Site Plan Review

1st Review

Site: 27000 Southfield Road – Discount Tire
Applicant: Joseph Westerbeke, PE
Plan Date: 03/19/2021
Zoning: Commercial-Vehicular District, MX- Mixed Use District, Single-Family District
Parcel ID: 24-13-359-007; -016; -052; -054; -061
Status: **READY FOR PLANNING COMMISSION CONSIDERATION**

Proposed

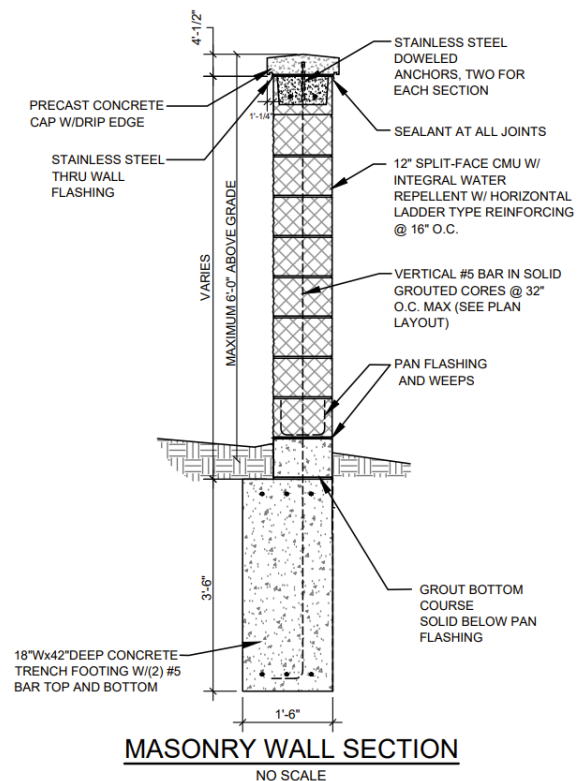
- a. **Paving the residential zoned parcel for 14 surface parking spaces.** The spaces will take access from a 20' wide public alley that separates the parcel from the service center to the west. A dumpster enclosure will remain on the parcel but will be relocated to the southeast corner abutting an east-west alley. A 6' tall, opaque, masonry wall and landscaping will serve as a buffer to separate the commercial improvements from the adjacent single-family residential property.

- b. **A 722 square foot addition to the north side of the existing building.** This addition will provide indoor storage for dead tires. Tires are currently stored in a mobile storage crate adjacent to the building, as well as outside against the crate, as observed during a site visit.

- c. **Relocation of parking.** Existing parking along the public alley, north of the building, will be relocated to the residential parcel on the east side of the alley. A new loading berth will abut, and run parallel to, the alley from Sunnybrook Avenue to the new tire storage addition. The dedicated loading area is intended to ensure the 20' wide alley remains free and clear of parked delivery vehicles.
